Product Change Notification

PCN-10624

ODD, DAD, DDA, DDB, DDC, XDA, and XDB Series Design Improvement

Distinguishable Characteristics

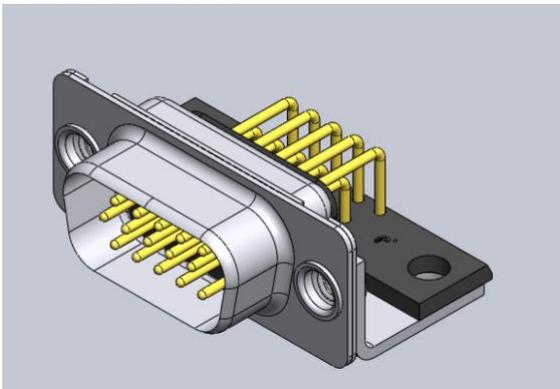
Printed board mount contacts shall be designed to use the larger bend radius to improve manufacturability. Board and mating dimensions are not affected.

Alignment bar will be shortened.

Current Female Solder Cup Contacts
(Shorter Tails)

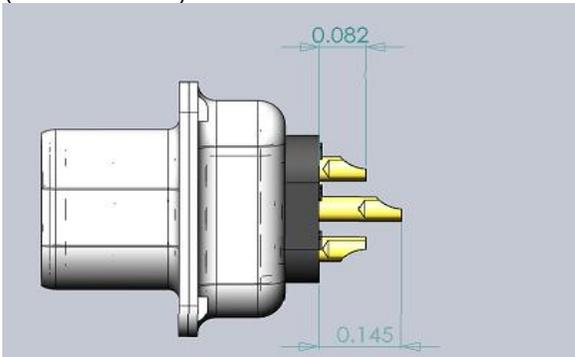
Solder cup contacts will increase in termination length.
